New Local Plan

Consultation response from London Borough of Merton Opposition Group - Liberal Democrats

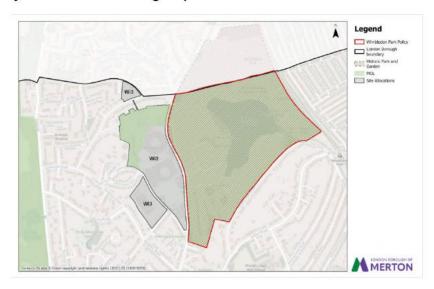
Whilst some parts of the chapter come from the original site allocation, we feel it is drafted in a way that attempts to be 'all things to all people'. By starting the chapter with 'We will do this by supporting development proposals that...', it frames everything that follows in a way that accepts the premise that the site should be developed in the first place. With the new policy only covering the geographical area outlined in red below, this is not the position of many residents or local groups:

The area marked out in red above includes three different owners and despite what is written on the page, the reality on the ground is that anglers are having issues with getting access to the shoreline to clear detritus. Within site allocation **Wi3** for AELTC (*page 308*), as the boundary has changed, reference should not now be made to the lake. Whilst the lake remains in the ownership of London Borough of Merton with these changes, we would want this to continue to be the case to ensure that residents retain access. We support the addition of the final paragraph: **8.1.30.** 'Given the size of this historic asset and its London location, the lake shoreline currently has very limited public access. We will work with all landowners to improve public access around the whole lake, taking into account biodiversity habitats, sporting, safety and reservoir management considerations.' As mentioned above, access to the lake should not be used as a 'trade off' for otherwise inappropriate development. We also note that access to the lake by means of a walkway around its entirety is currently required under the terms of the covenant agreed by the AELTC when they bought the golf course land and effective from when it ceased to be used as such.

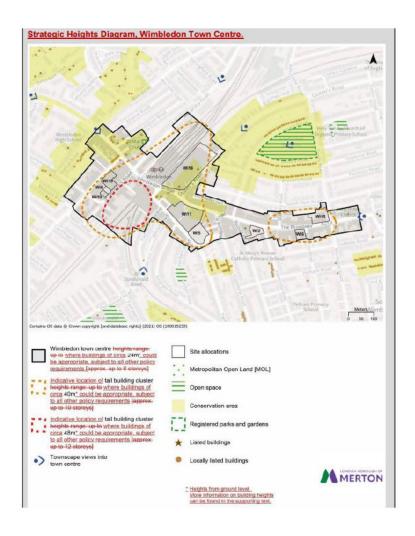
Of much interest to residents will be **Policy D12.6** on 'Tall buildings' - This should be read in conjunction with the Strategic Heights Diagram for Wimbledon Town Centre, copied here:

We would ask for clarity please to the yellow and red dotted lines on indicative heights. We do not support *Paragraph 5.3.60* of the Future Wimbledon Supplementary Planning Document, which allows for buildings to be higher than those specified in the Document and feel that the Local Plan is an opportunity to remedy this. If 40m buildings are to be constructed in Wimbledon Town Centre, the dotted indicative location lines should be contained within the black line boundary, and these should end at Francis Grove rather than extending to residential Tabor Grove as they do in the image above. The potential for 48m tall buildings, (marked with the red dashed line) should also not be permitted to extend beyond this location. We are also of the opinion that the limitation on tall buildings should be rigorously applied by the planning authority.
